The text reproduced below reflects the state of play of the discussion of the SIG UNR157 up to its 7<sup>th</sup> meeting on raising the specified maximum speed of ALKS up to 130 km/h. It is based on ECE/TRANS/WP.29/GRVA/2020/32 (DE) and subsequent amendments received on this proposal.

## I. Proposal

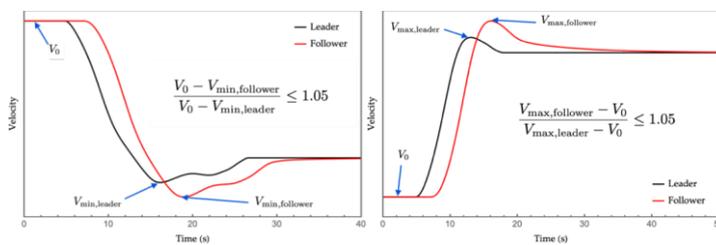
*Point of discussion on 5.2.9. and 5.2.10: Agreement to include some aspects of proposals from JRC/EC (UNR157-03-06) on "string stability" as general requirements. Leadership to prepare proposal. → Group needs to review proposal by leadership.*

**[5.2.10 — While following another vehicle the ALKS vehicle shall aim to be string stable.**

**In particular, when following another vehicle at constant speed and at a distance such that the speed profile of the ALKS vehicle is influenced by the speed profile of the vehicle in front, the ALKS vehicle shall aim to respond to a perturbation in the speed of the vehicle in front with a perturbation in its speed profile by at most a 5% increase in the maximum difference in speed compared to the vehicle in front before reaching a new equilibrium velocity following the visual examples reported in the following figures.**

**Figure 6**  
Flow-chart of the second ALKS performance model for the case of the cut in traffic critical scenario

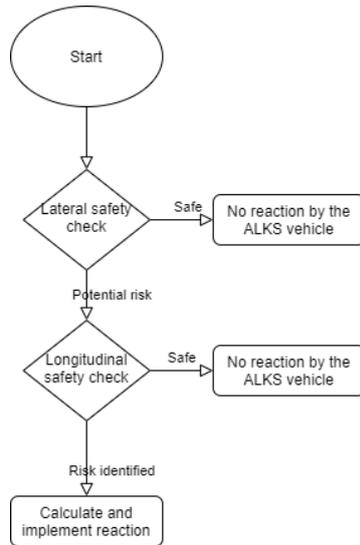
Commented [KT(6)]: Equation needs to be added.

**Commented [KT(7)]:** This refers to the software implementation of the model to derive the performance criteria, but not automotive software implementation to be used in the ALKS system, correct? If yes, this should be clarified as the common understanding was that this model would not need to be implemented in ALKS system design to meet the requirements.
